**Device**                **TC1797**  
**Marking/Step**      **QS-AC**  
**Package**             **P/PG-BGA-416-10**

## 01961AERRA

This Errata Sheet describes the deviations from the current user documentation.

**Figure 1 Timing concerning equidistant multiple timers**

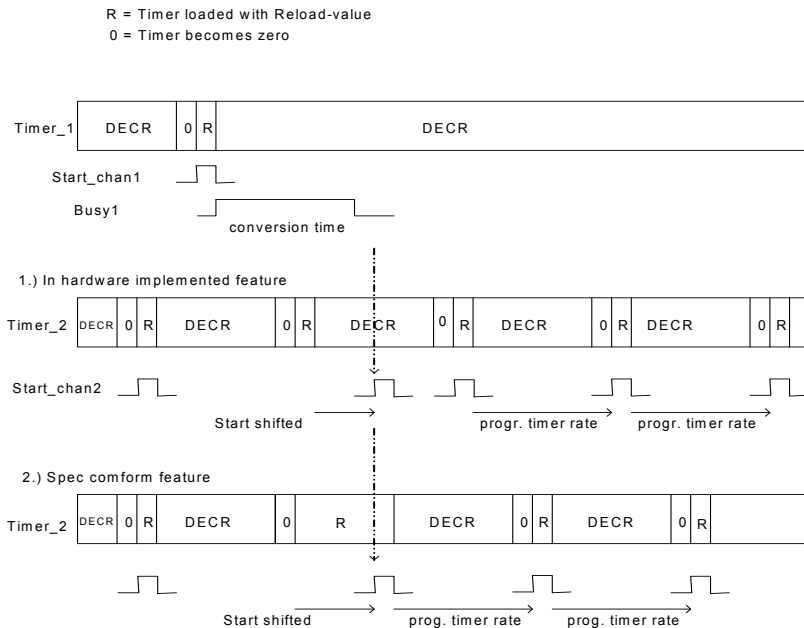
**FADC\_TC.005 Equidistant multiple channel-timers**

The description is an example for timer\_1 and timer\_2, but can also affect all other combinations of timers.

Timer\_1 and Timer\_2 are running with different reload-values. Both timers should start conversions with the requirement of equidistant timing.

The correct behavior would be a reload when the requested conversion (of channel\_2) is started.

Therefore the start of conversion for channel\_2 is delayed by maximum one conversion-time. After this delay it will be continued with equidistant conversion-starts. Please refer to the following figure.

**Figure 2 The second frame starts in the same slot**

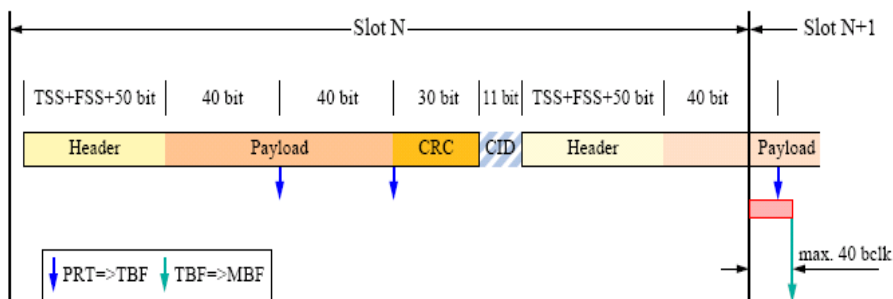
## Scope:

The erratum is limited to cases where the complete header and a part of the payload of another frame is received in slot N.

The transfer of a received valid frame from TBF to MBF is initiated by the end of the actual slot. Execution is started not later than 40 bclk periods after the slot change. 40 bclk periods equate 10 bit times, when bclk=40MHz. Corruption of payload occurs when a transfer from PRT to TBF happens in the red marked time window between start of new slot and start of transfer from TBF to MBF.

**Figure 3 Loss of Arbitration**

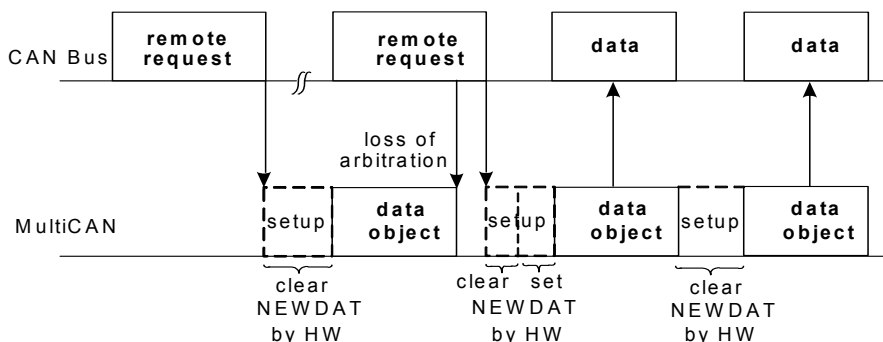
When the appropriate message object (data frame) triggered by the first remote frame wins the arbitration, it will be sent out and `NEWDAT` is not reset. This leads to an additional data frame, that will be sent by this message object (clearing `NEWDAT`).

There will, however, not be more data frames than there are corresponding remote requests.
